Victoria Point Manchester

Empiric Student Property PLC
NMA - Blocks 2-4 Amendments

16/01/2026
Issue 03

Non-Material Amendment

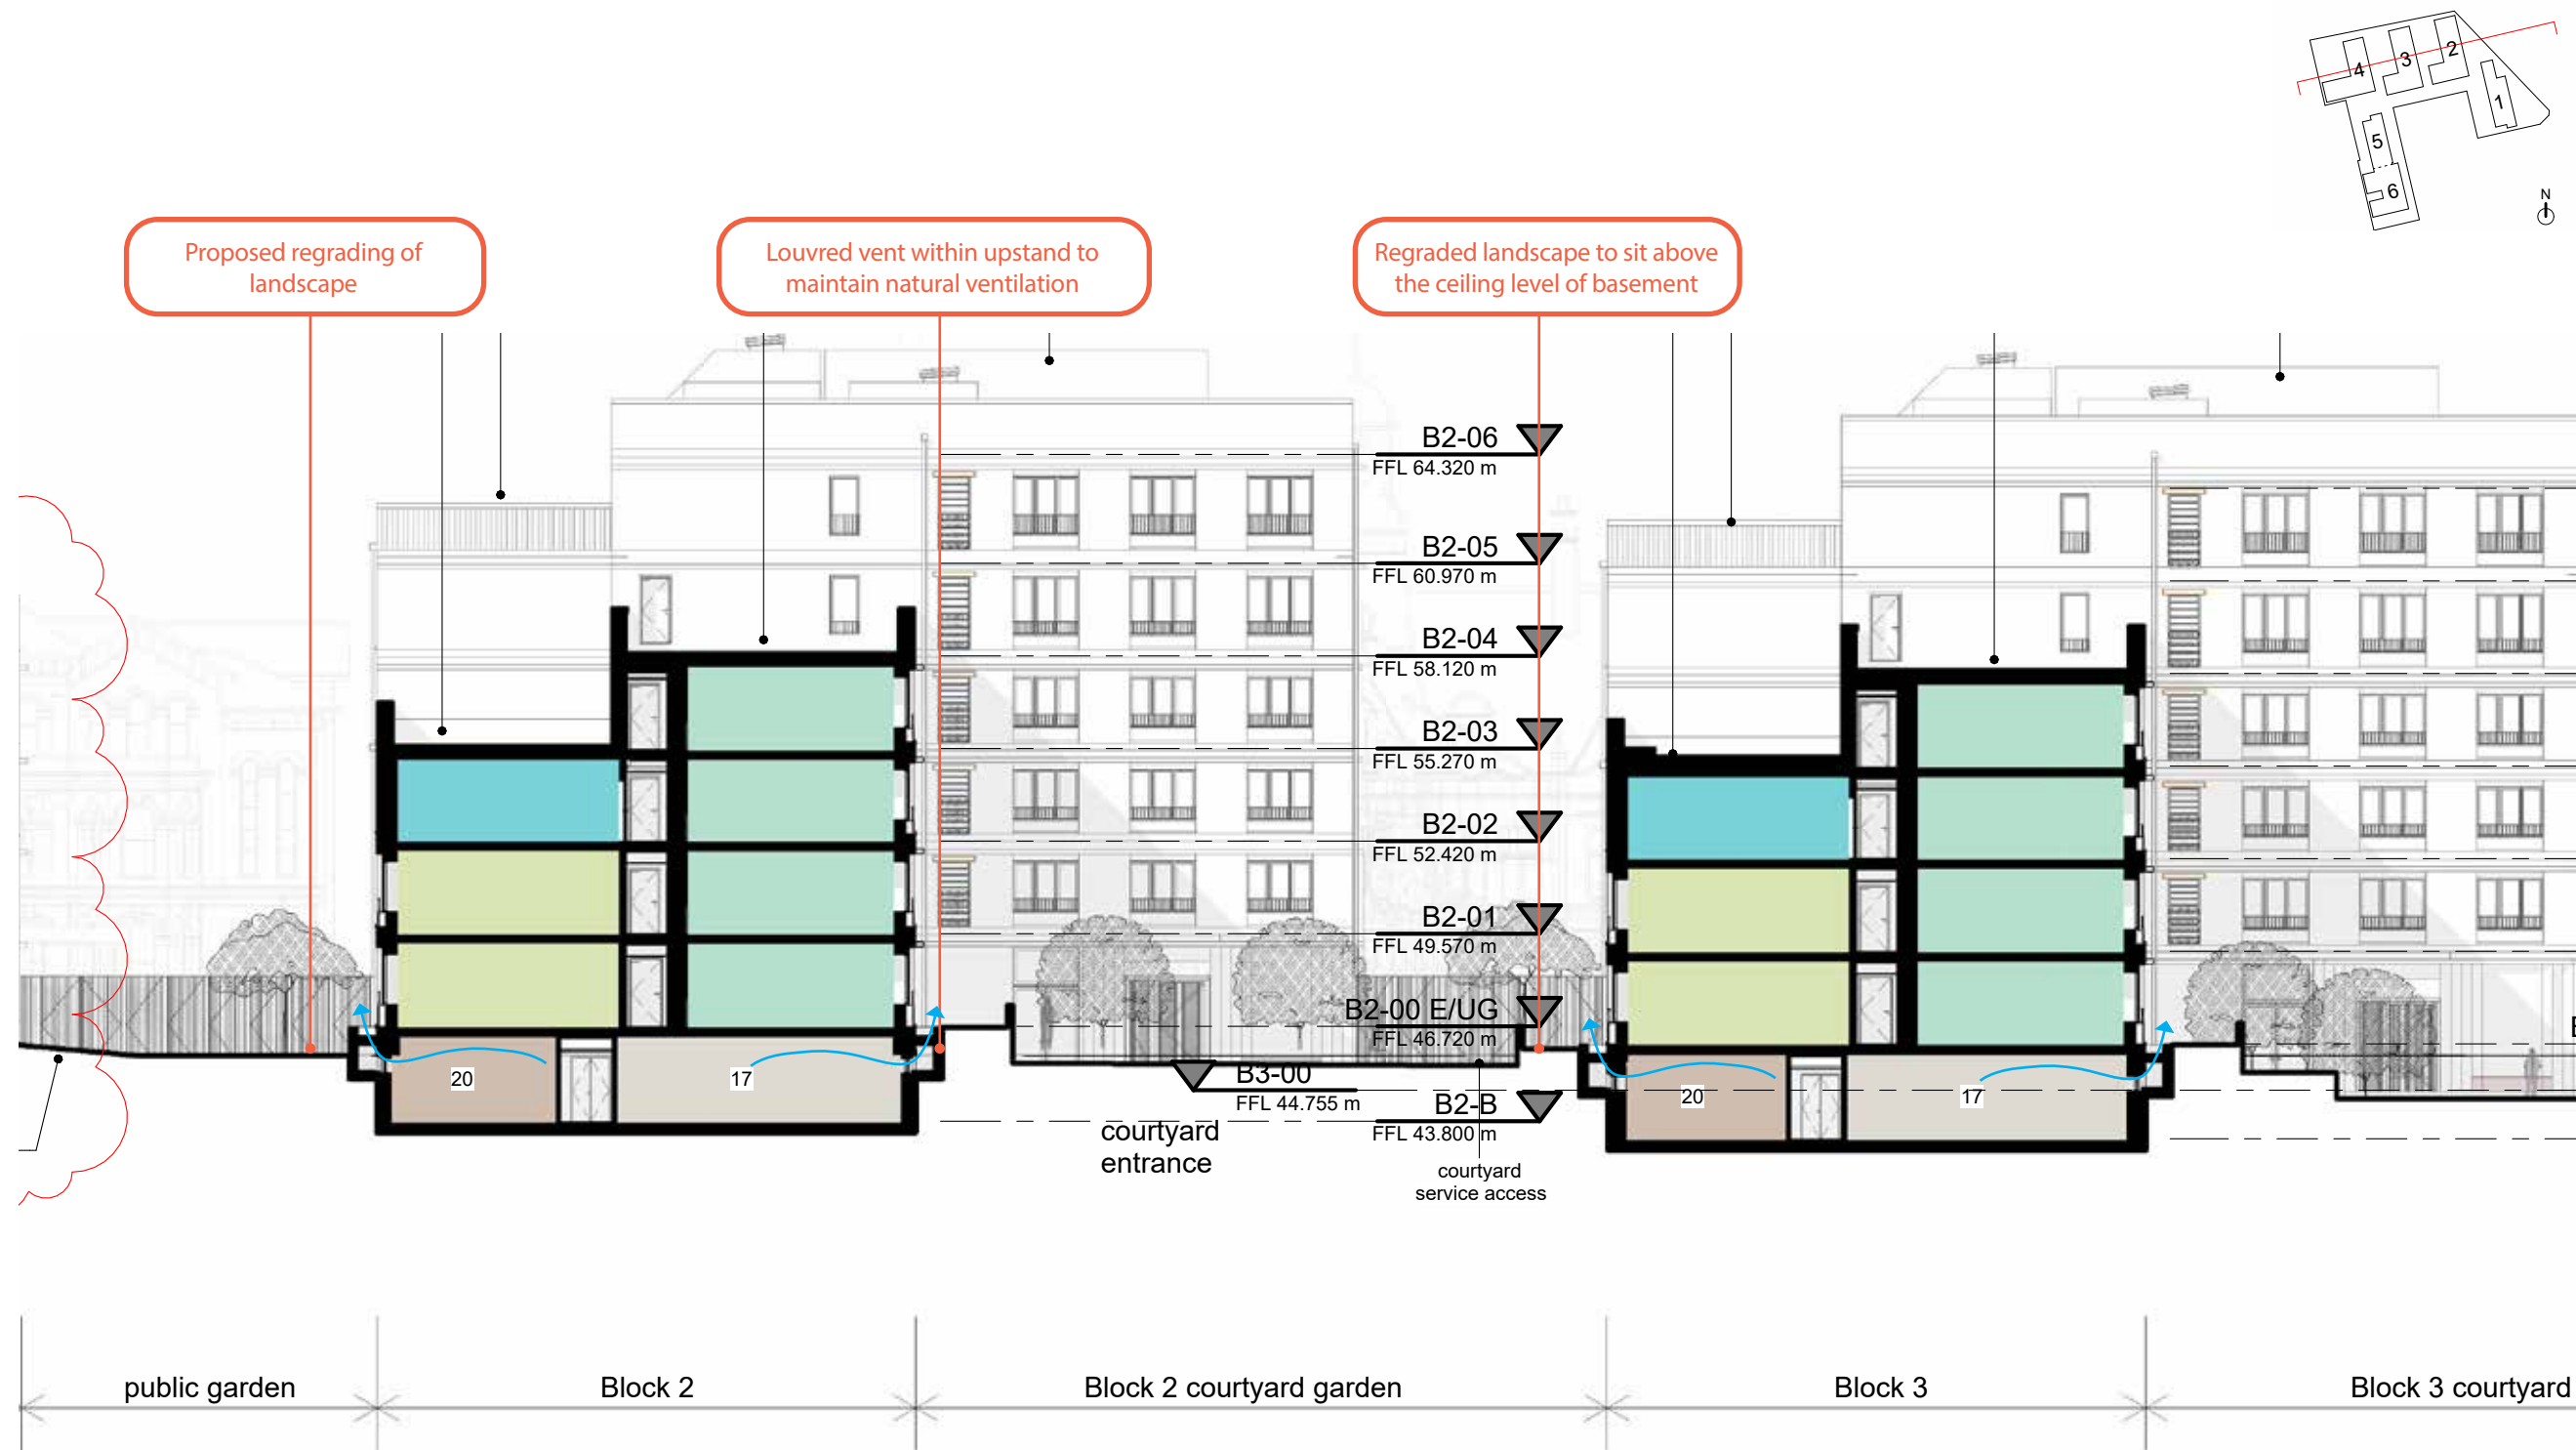
In section we can see what is intended. In red are the areas that are in addition to the existing site levels. This regrading will create a basement condition to these blocks. To allow for smoke ventilation, a series of grilled ducts are proposed at ground level (refer to section 2 for further information)

Section through smoke vent

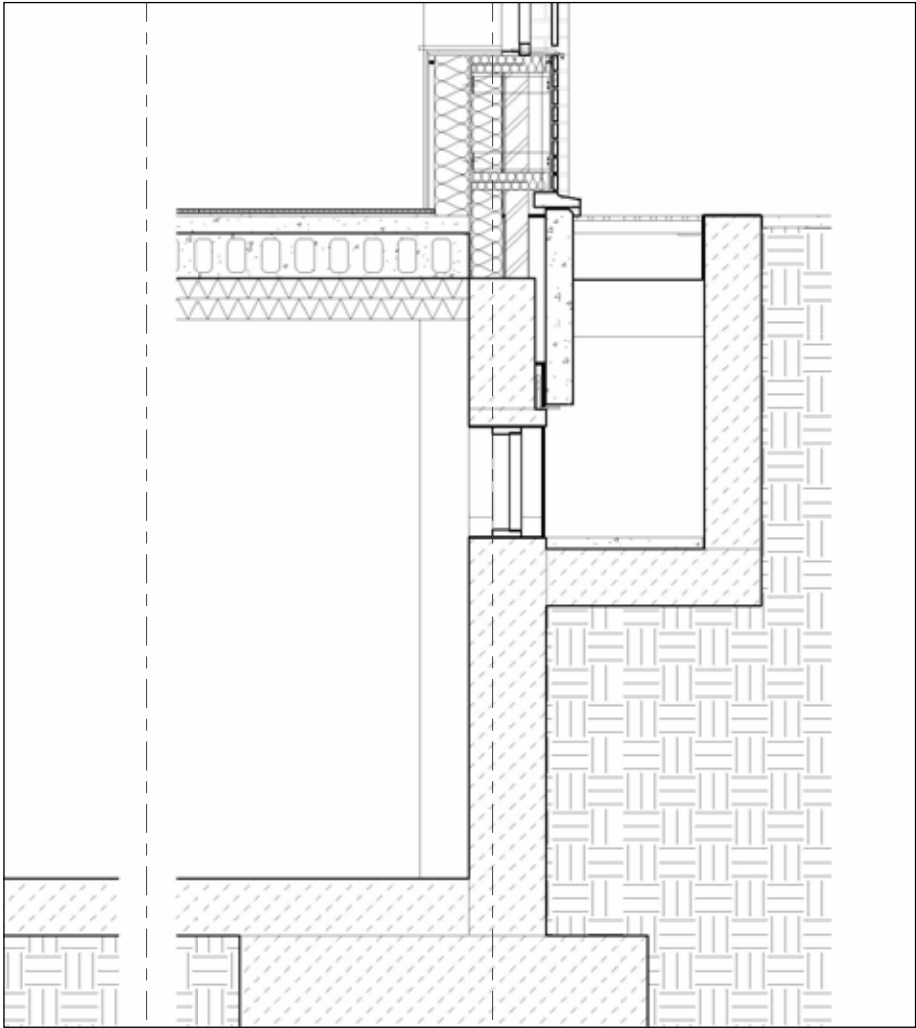
To facilitate basement smoke ventilation, a series of grilled smoke vents are proposed along the east and west portions of the block at ground level. These will be inaccessible to the public, screened by planting, however they will be accessible for maintenance if required.

The grilles are to be stainless steel open grilles to allow for free air movement. The vents will have a gulley to allow them to be drained.

Proposed Block 3 lower ground floor plan

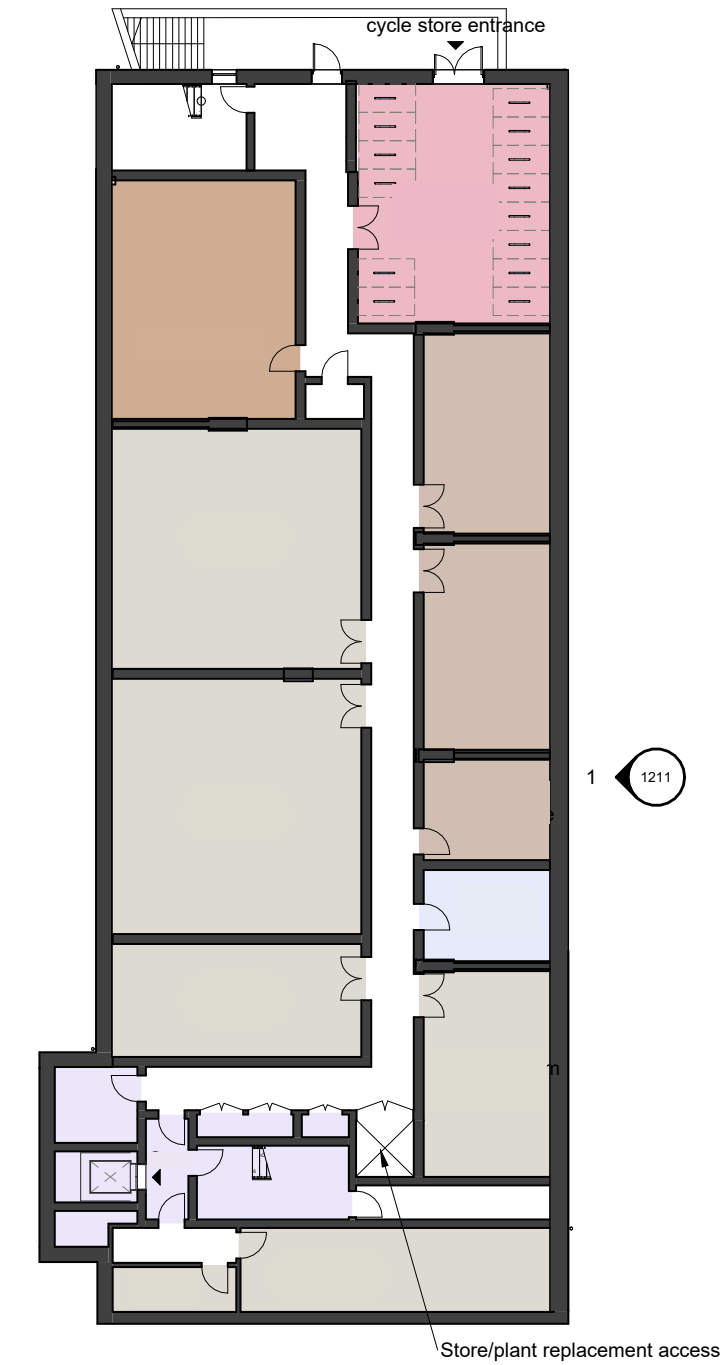
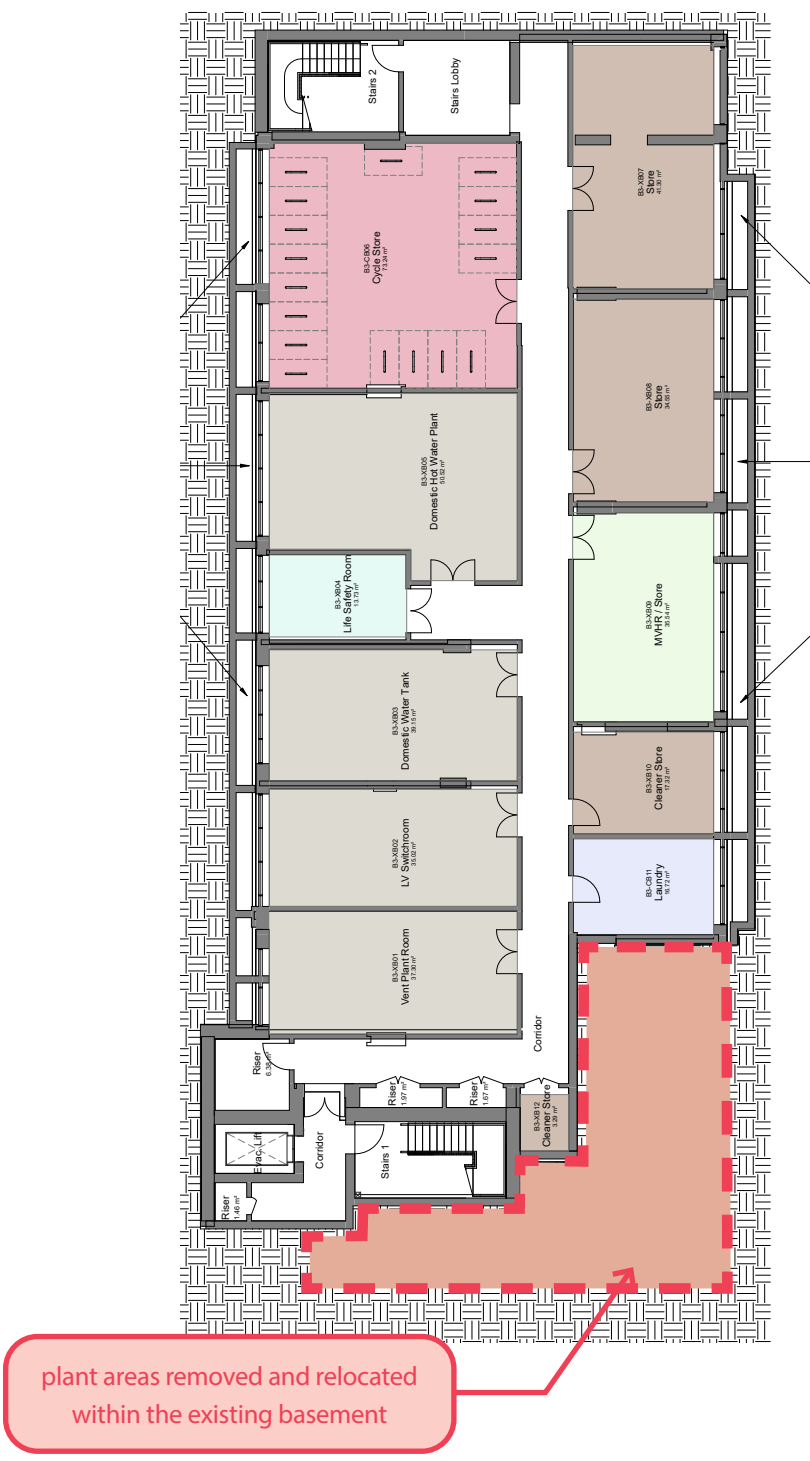
To the front of Blocks 2 and 3, the HV room and plant room are to be relocated to the rear in place of the storage room.

Raised planters are proposed to the edge of the building along its south-eastern edge to provide a line of retention for the reprofiled courtyard landscape.

Proposed Site Wide Landscaping Plan

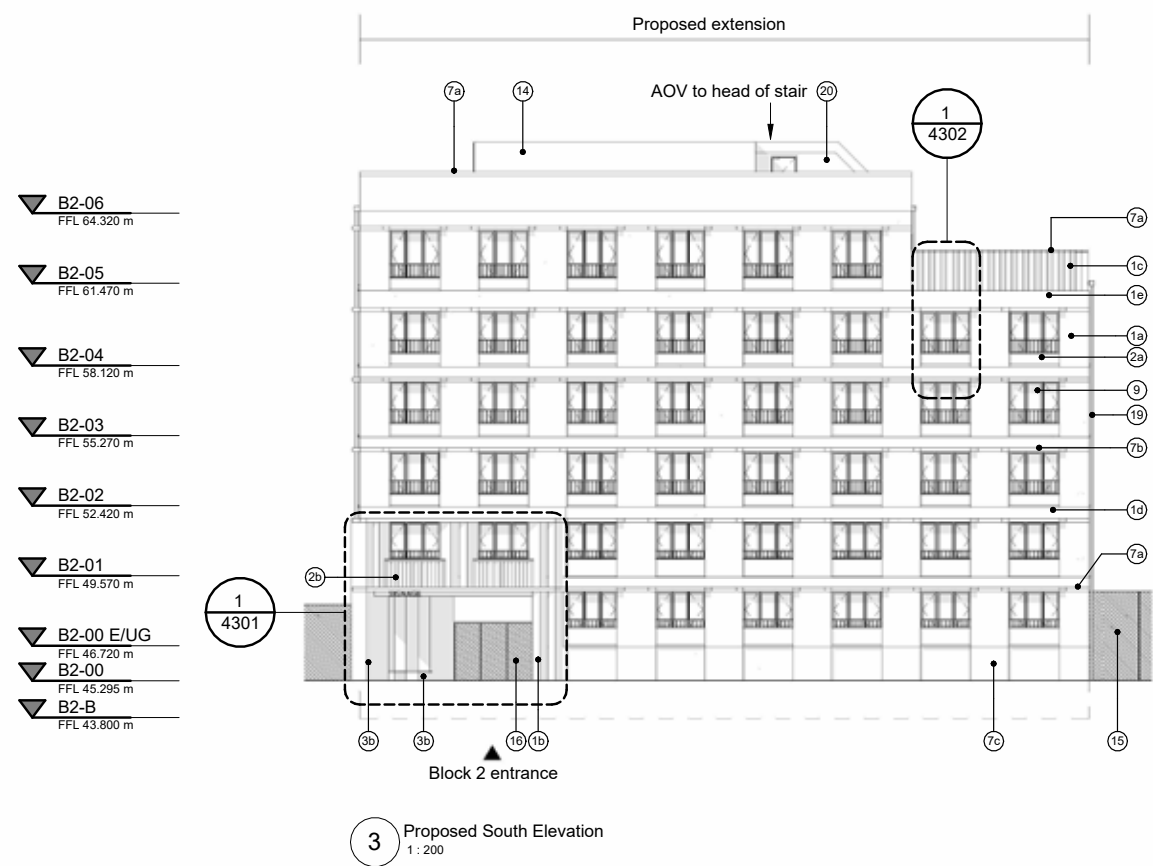
- The principle changes to the wider landscaping are:
- › changes to the layout and levels of the courtyards between Blocks 2, 3 and 4
 - › adjustments to the cycle store footprint and stepped access to the rear of Blocks 2 & 3
 - › minor adjustments to the Block 4 terrace
